# Exploded drawings

## Electric and Gas Combisteamer Gold

European CE-Version

## New cabinet door and door gasket for 6.x & 10.x

### Chassis door area HD20.x, right hinged (Electric)

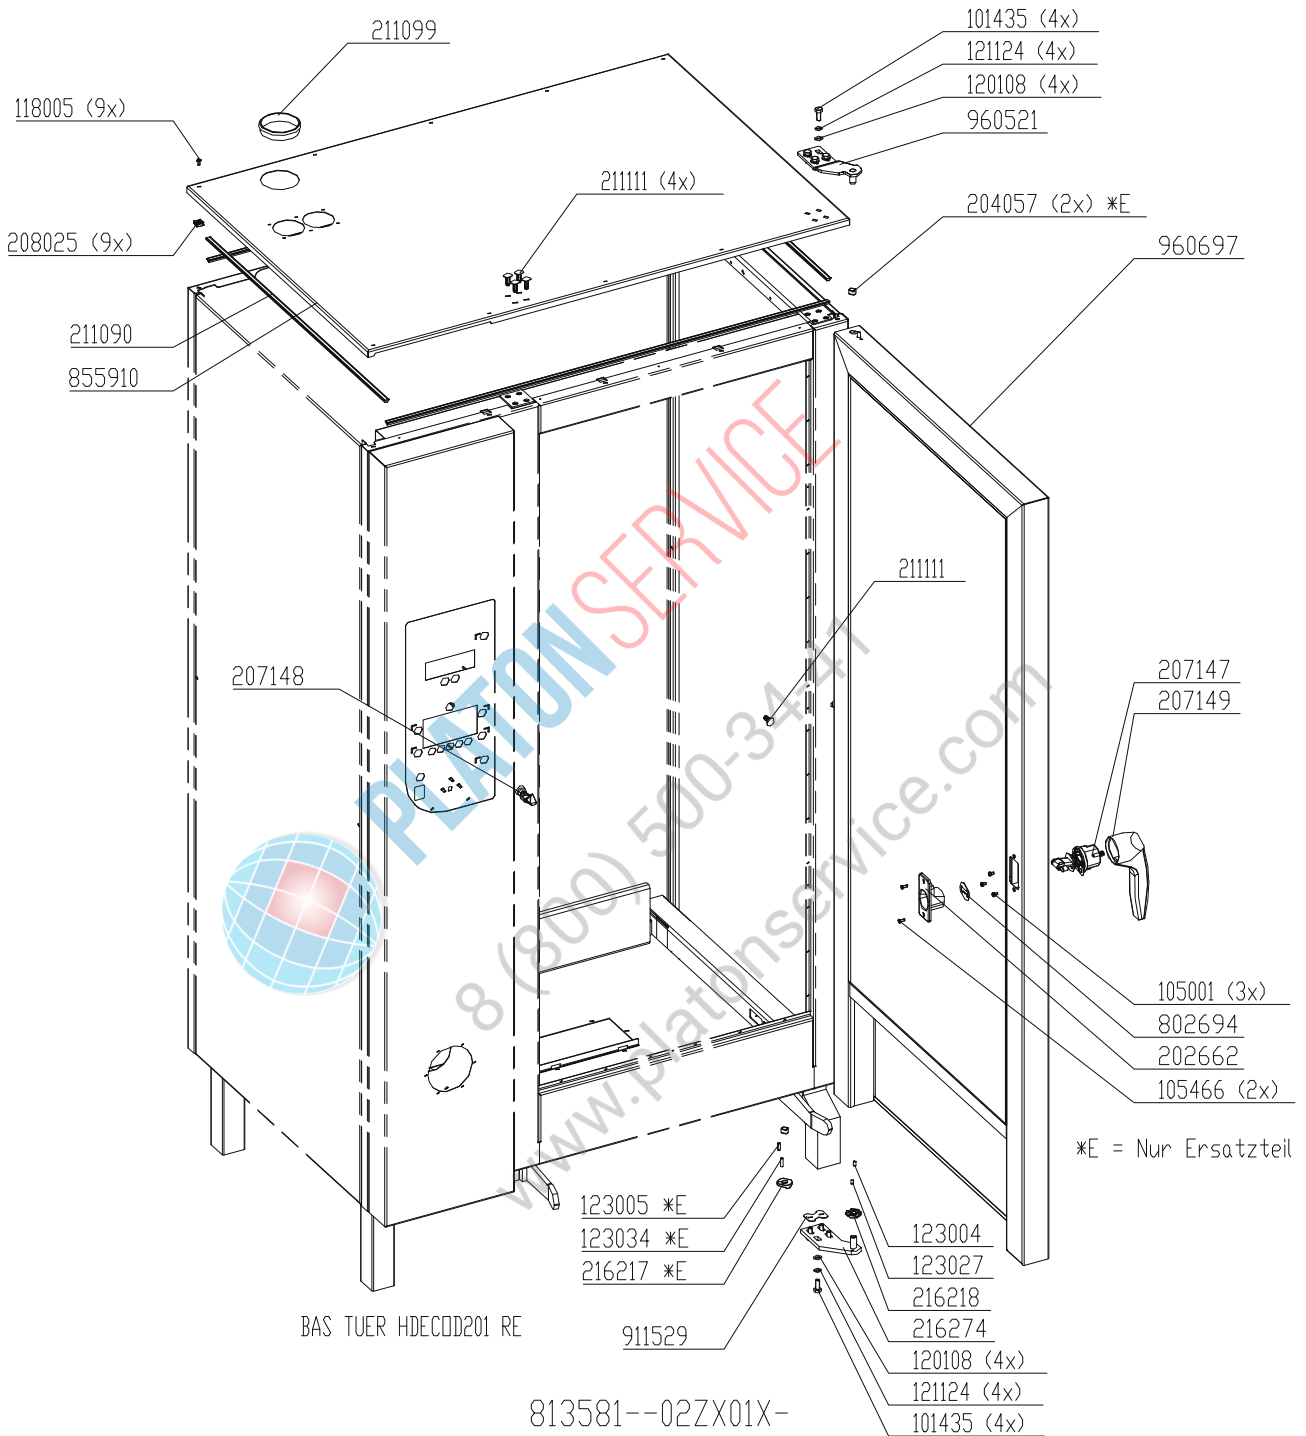
Bis S/N 09021515: #211104 Profildichtung Garraumtür (mit Pactan eingeklebt)  
 Ab S/N 09021516: Steckbare Profildichtung #211171

### Chassis door area HD20.x, left hand hinged (Electric)

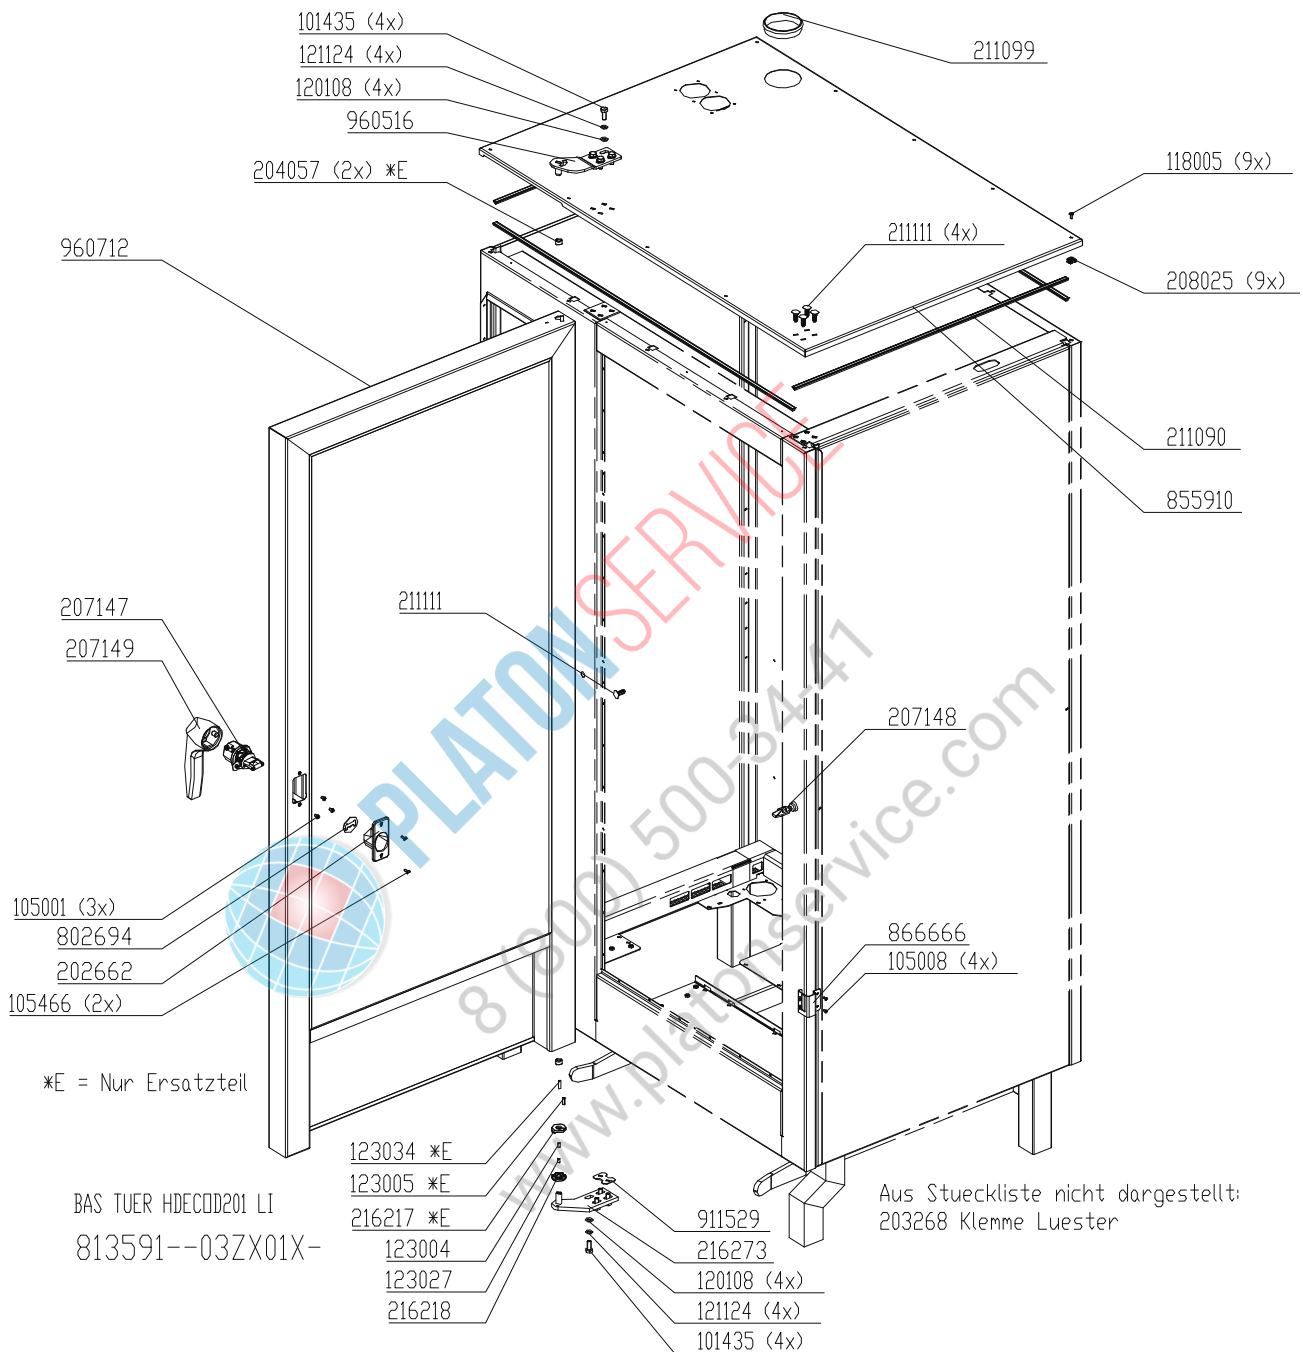
Bis S/N 09021515: #211104 Profildichtung Garraumtür (mit Pactan eingeklebt)  
Ab S/N 09021516: Steckbare Profildichtung #211171
